TRAVEO™ T2G CYT4DN errata sheet

Marking/Step: Rev. C

32-bit single-chip microcontroller

Figure 1 Rx Buffer and FIFO Element

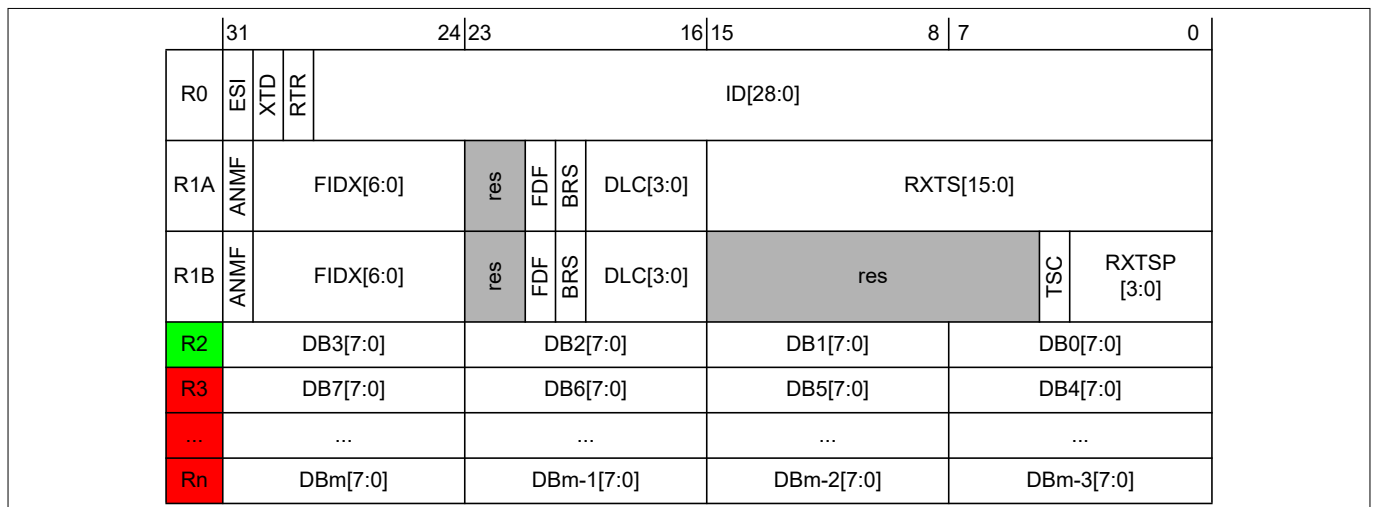
Received data bytes (DB0..DBm) from the CAN Core are buffered in the cache of the Rx Handler before they are written to the Message RAM (in words of 4 byte). Data words inside the Message RAM are numbered from R2 to Rn ($n \leq 17$).

Figure 2 CAN frame with $DLC > 4$

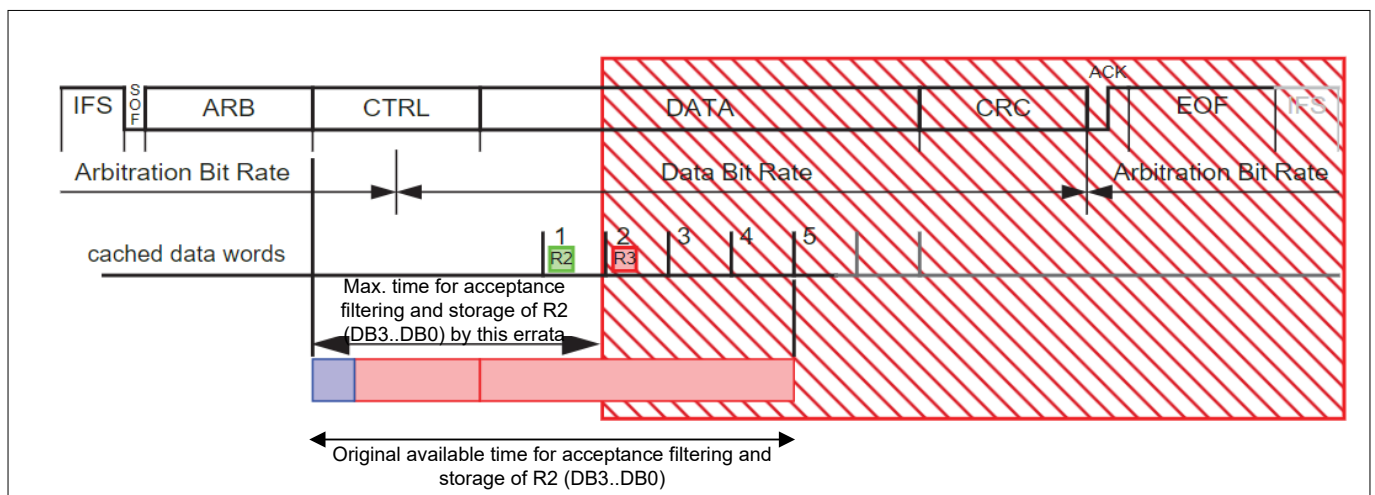
Under the following conditions a received message will have corrupted data while the received message is signaled as valid to the host.

Figure 2 shows how the available time for acceptance filtering and storage is reduced.

Due to condition 3 the issue occurs only sporadically. Use an end-to-end (E2E) protection (for example, checksum or CRC covering the data field) and add it to all messages in the CAN system, to detect data corruption in received frames.
